Title: Cavalon window strength improvement		
AG-SB-2022-08-C-EN	Effective Date: 26.09.2022	Compliance Category: A - MANDATORY B - RECOMMENDED C - OPTIONAL
Applicability		
Aircraft type & model: AutoGyro Cavalon	Affected Serial number(s): Up to SN V00533	
The maintenance manual to be referenced is this stated or subsequent issue.		As per AutoGyro website
This form is the response from AutoGyro GmbH either against a problem found in the product in service requiring a containment or rectification action, or as service information for aircraft modification incorporation. For help, contact airworthiness@auto-gyro.com .

Reason and overview of the Service Bulletin (cause of problem if known)

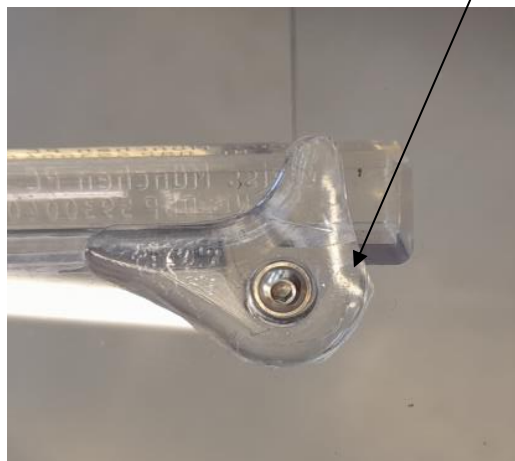
Due to improper opening and closing of the door via the ventilation window, cracks occasionally occur at the front lower corners of the ventilation windows at the screw connection.

In order to prevent cracks on the Cavalon cabin door, reinforcements have been developed to evenly distribute stress and stiffen critical areas of the cabin door.

- Uninstall the lower front screw
- Clean the outside surface of the cabin door with active glass cleaner (PN 30494)

Install reinforcement:

- Clean the surface of the reinforcement with Loctite 7063 Super Clean (PN 35915)
- Add the double-sided tape on the reinforcement
- Line up contour and hole of the reinforcement and cabin door when installing
- Put the screw back on

Tighten screws only hand-tight
